State of Hawaii
DEPARTMENT OF LAND AND NATURAL RESOURCES
ENGINEERING DIVISION
1151 Punchbowl Street, Room 221
Honolulu, Hawaii 96813

ADDENDUM NO. 2

Job No. F48C612A
Keaiwa Heiau State Recreation Area Water System Improvements
Aiea, Hawaii

May 19, 2026

INSET
 SCALE: 1" = 4'

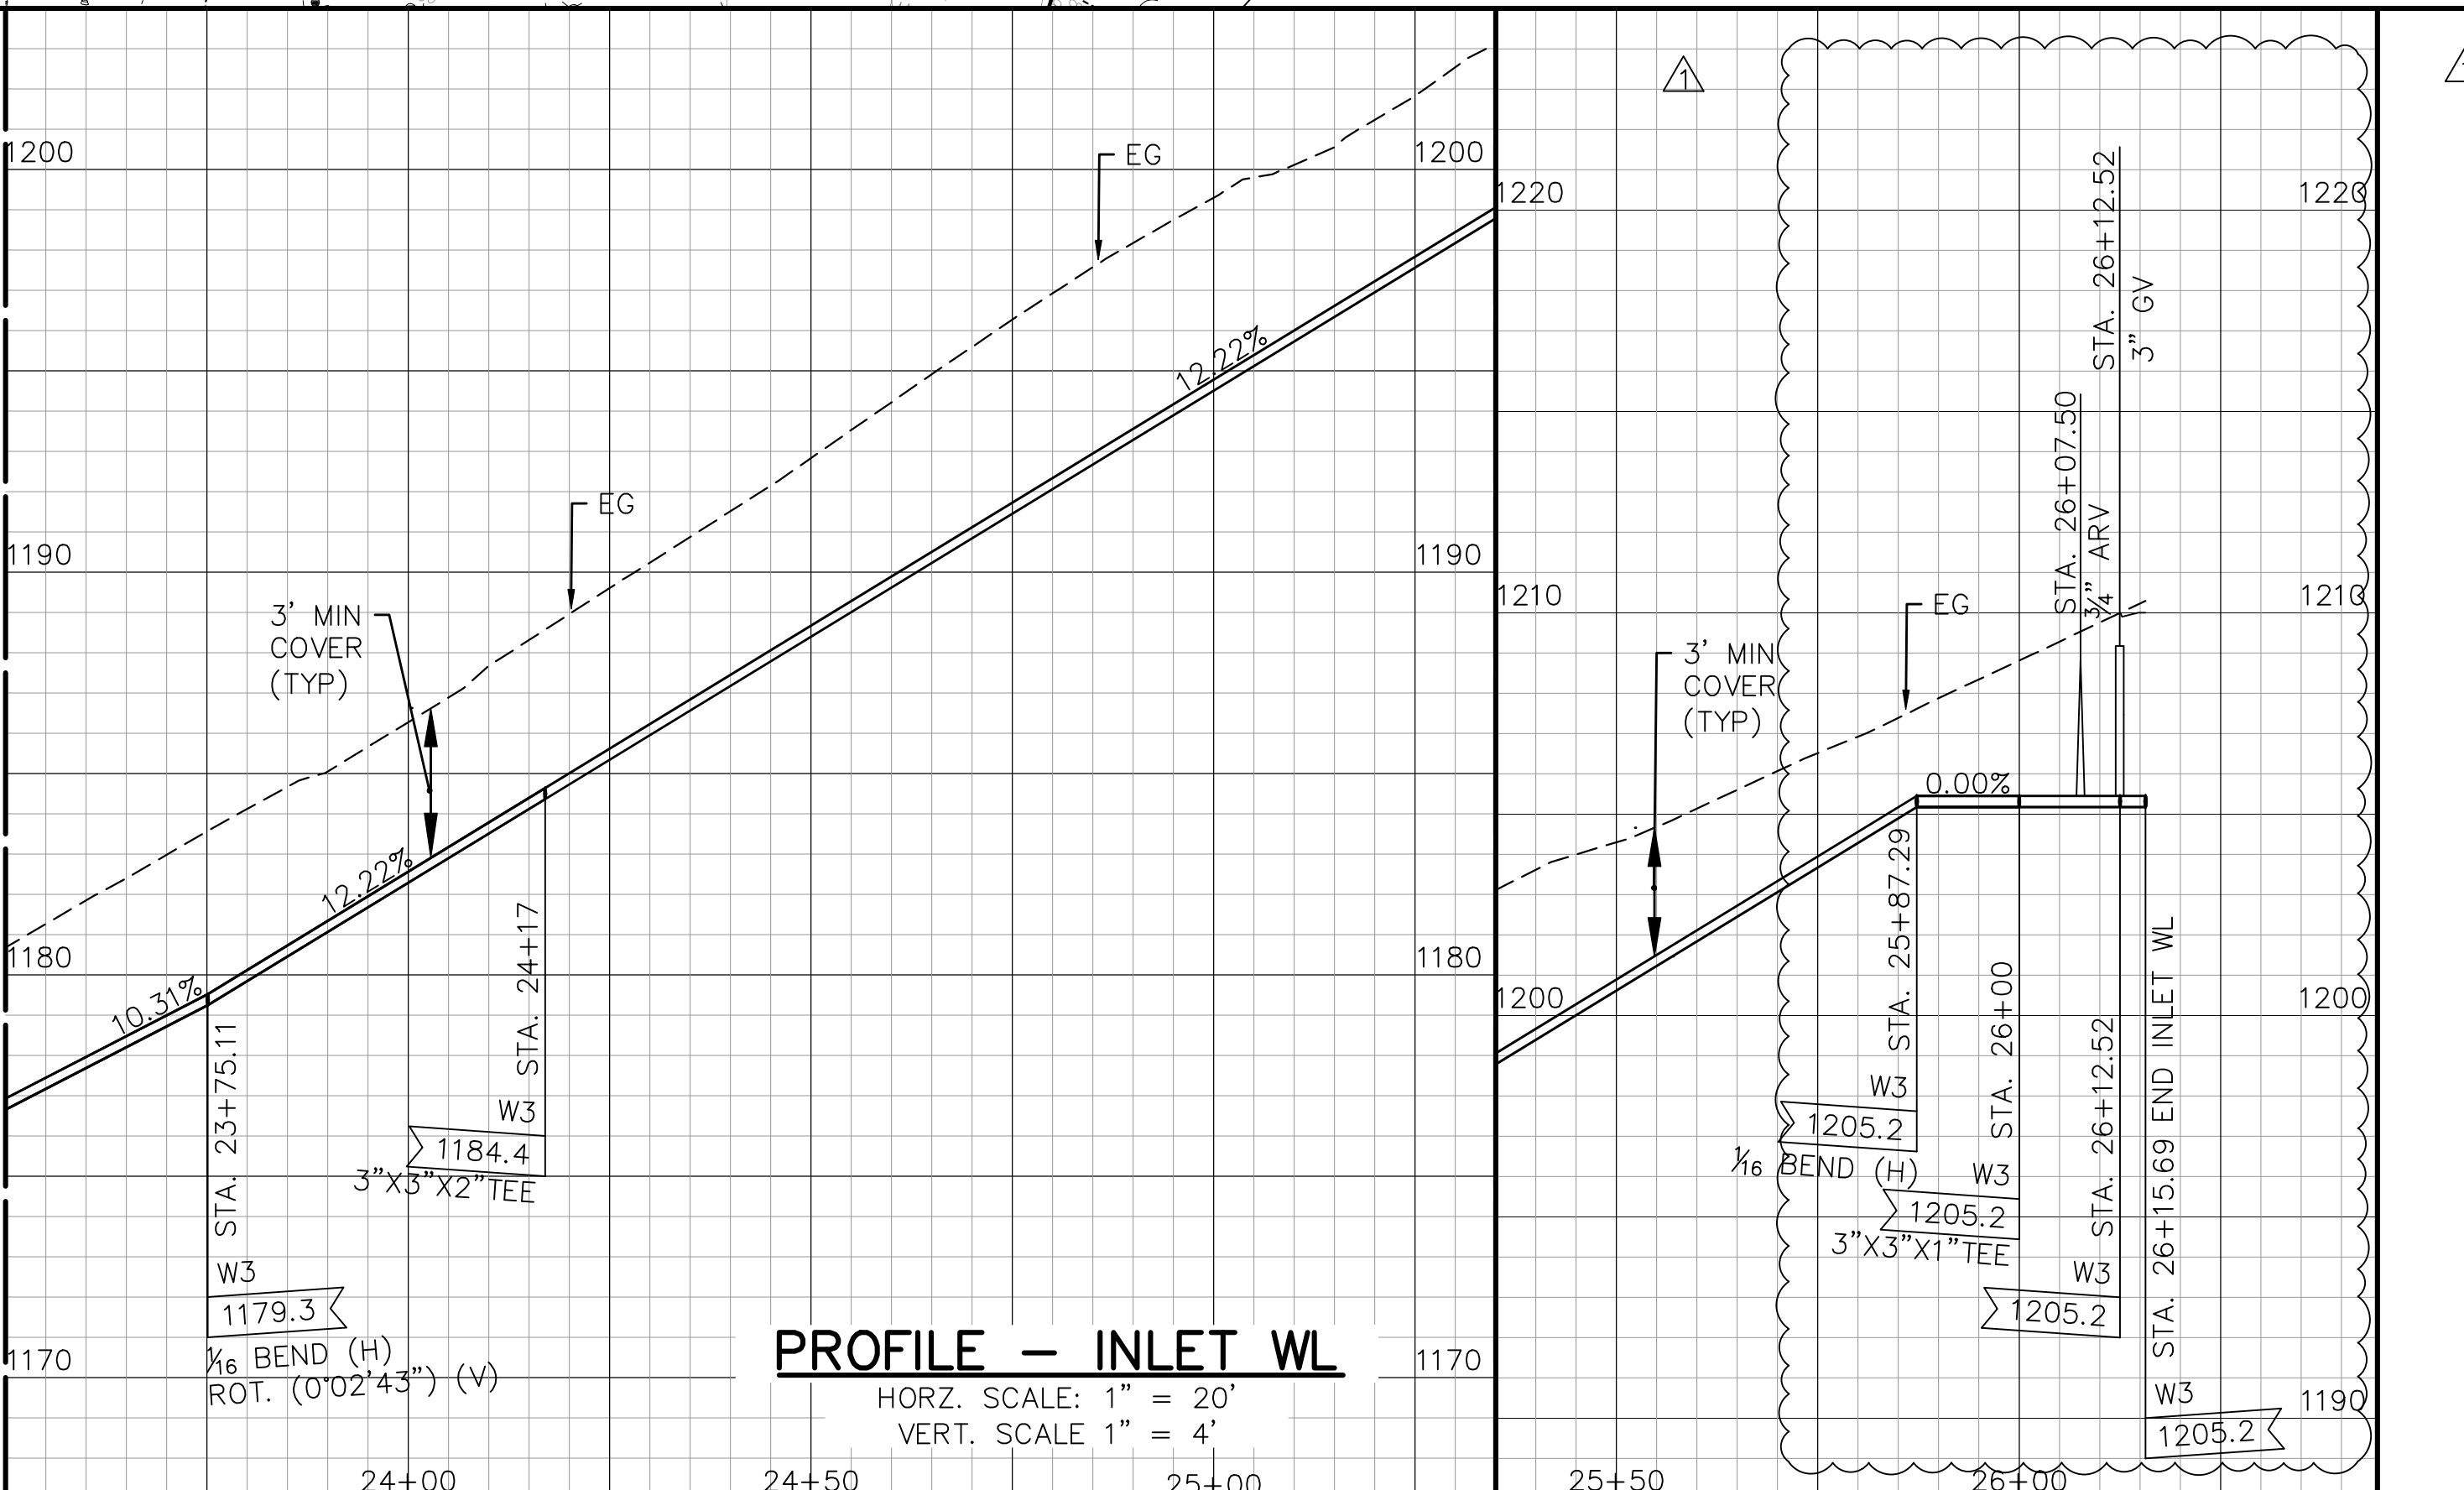
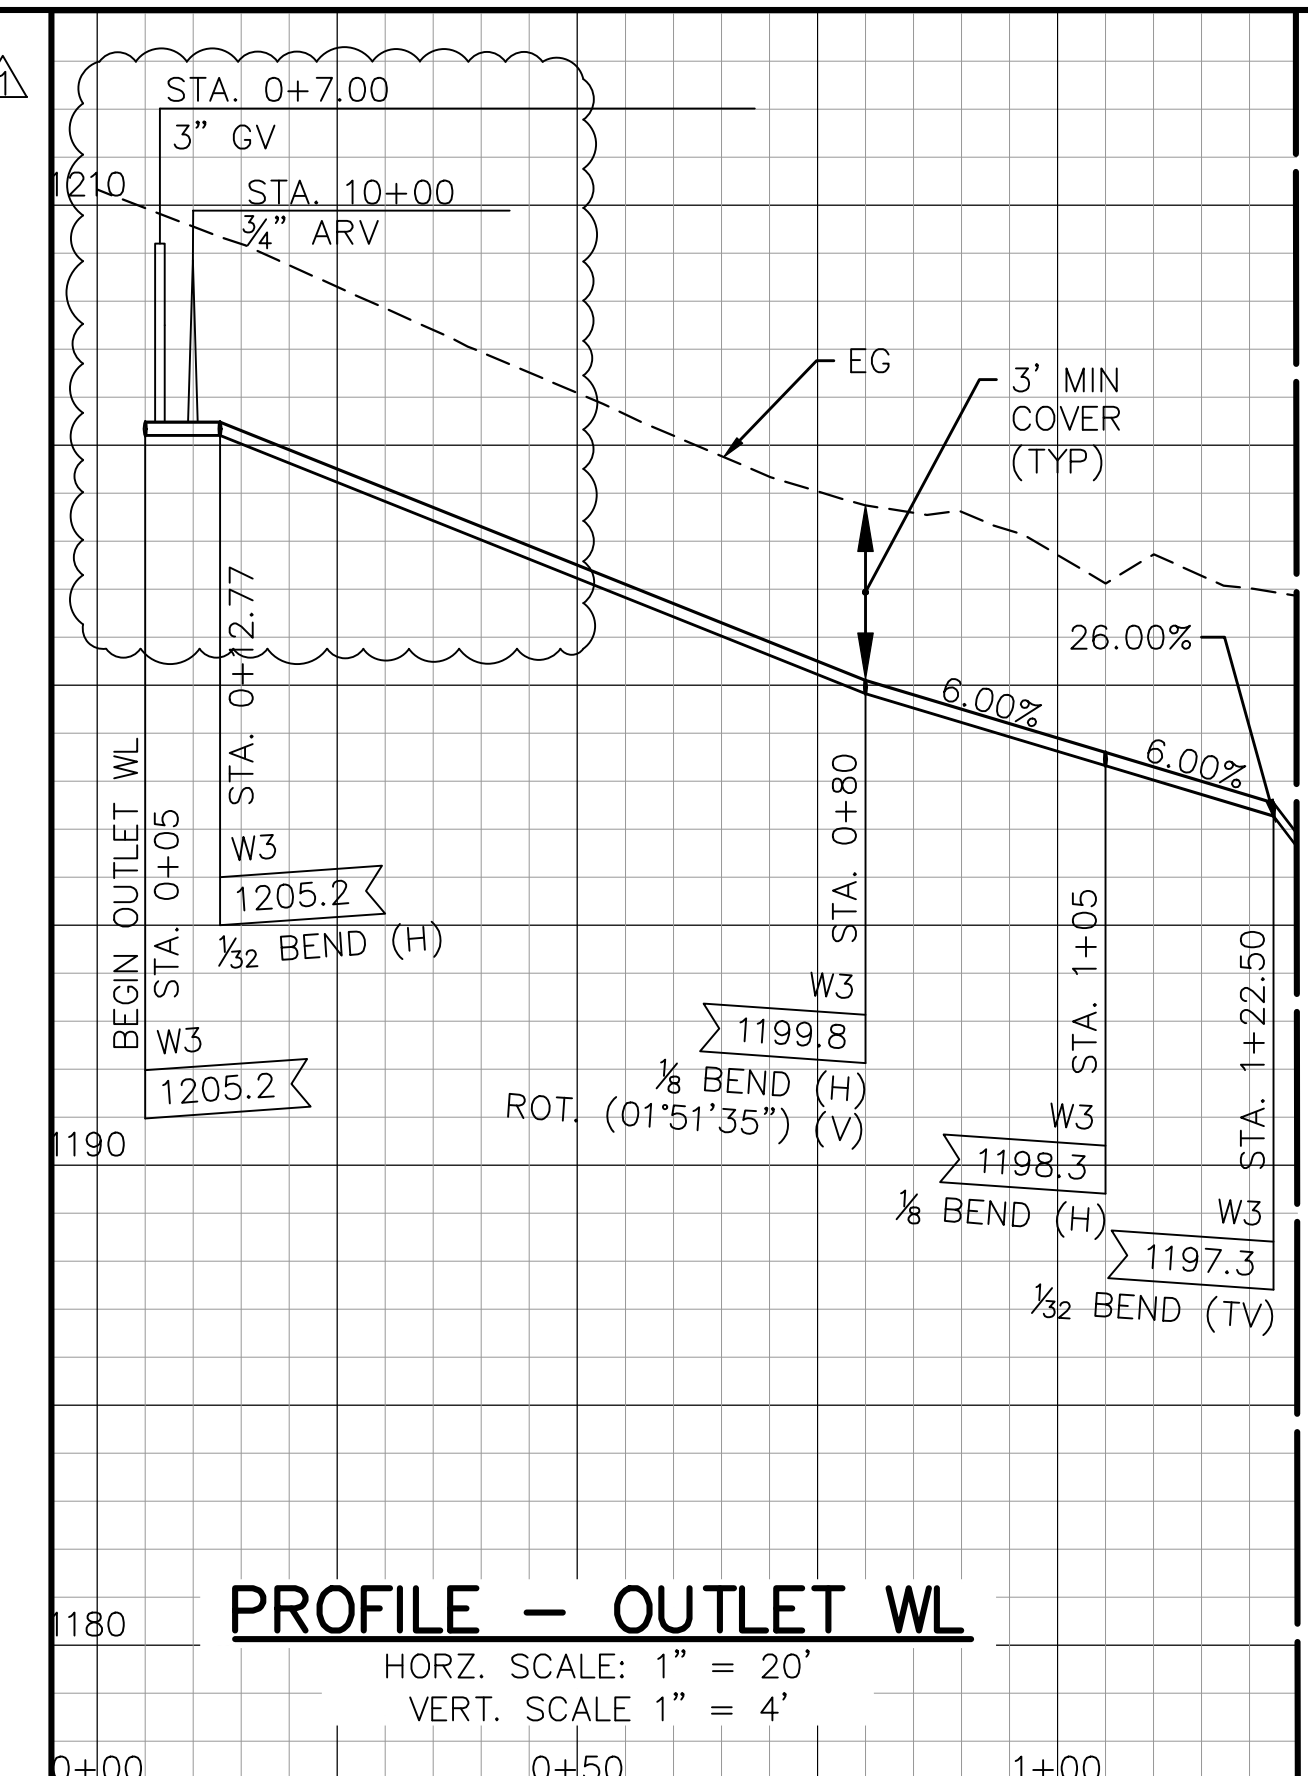
5. Sheet C-9 – Plan & Profile 4, Replace sheet with the attached revised Sheet C-9.
 - a. Added new quick coupling valve.
6. Sheet C-10 – Plan & Profile 5, Replace sheet with the attached revised Sheet C-10.

- a. Added new quick coupling valve.
 - b. Added new air relief valve.
 - c. Revised piping and tanks for bladder tank area.
 - d. Revised existing redwood tank structure to remain in place.

- 7 BEGIN OUTLET WL
 STA. 0+05 OUTLET WL
 = STA. 26+15.69 O/S 8' RT. INLET WL
 2 LF 3" TYPE "K" SOFT COPPER PIPE.
 1 - COPPER TO PVC TRANSITION ADAPTER
 CONN. TO NEW TANK. SEE DET. (1)
 C-16
- 8 STA. 0+12.77 INLET WL
 1 - 3" 1/2 BEND, (H)
 1 - CONC. BLOCK
- 9 STA. 0+80.00 OUTLET WL
 1 - 3" 1/2 BEND, (H) ROT. 01°51'35"
 1 - CONC. BLOCK
- 10 STA. 01+05.00 OUTLET WL
 1 - 3" 1/2 BEND, (H)
 1 - CONC. BLOCK
- 11 STA. 26+07.50 INLET WL
 1 - 3/4" ARV SEE
 SEE WSS STD DET. V2
 1 - 3"x3"x3/4" SCH 80 PVC TEE
- 12 STA. 0+07.00 OUTLET WL
 1 - 3" GV SEE DET. (3)
 1 - 12" VALVE BOX (C-16)
- 13 STA. 0+10.00 OUTLET WL
 1 - 3/4" ARV SEE SEE WSS STD DET. V2
 1 - 3"x3"x3/4" SCH 80 PVC TEE
